Steering Control Linkage

This documentation displays the changes made to the steering control linkage. This change will increase operator comfort by providing smoother steering control. The new rod ends and levers location will eliminate the possibility of the rod ends becoming damaged.

**** Effective date: 10/10/2008 ****

New Assembly

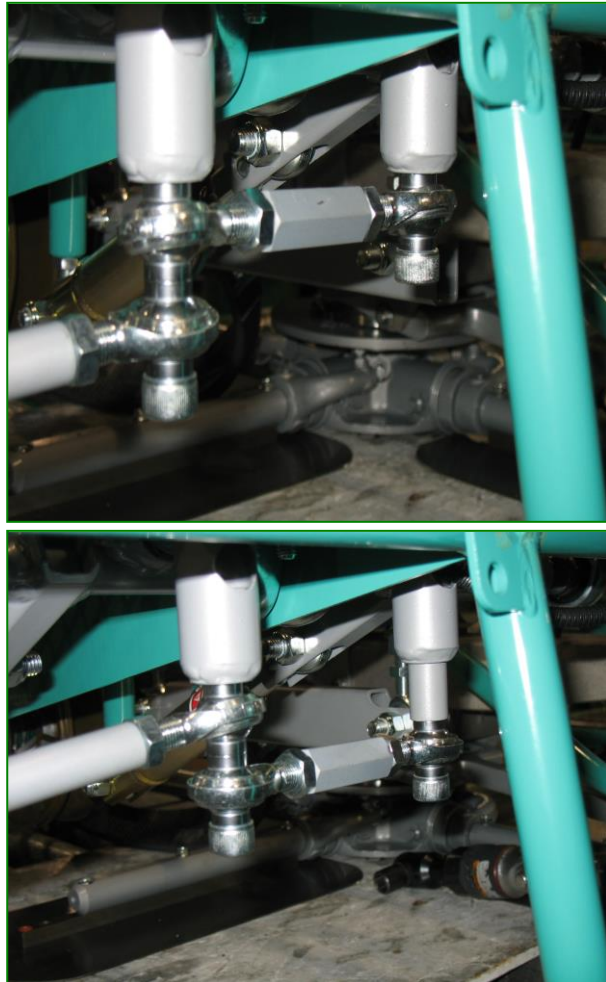
For reference this is the old assembly arrangement. Notice the location of the linkage.

This is the assembly arrangement of current production with the new rod ends, spacer and coupling nut. Notice the location of the linkage

All H-series mechanical ride-on trowels with a starting serial number of YJ0206770 will have this new steering control linkage. This change is applicable to all H-Series mechanical trowels.
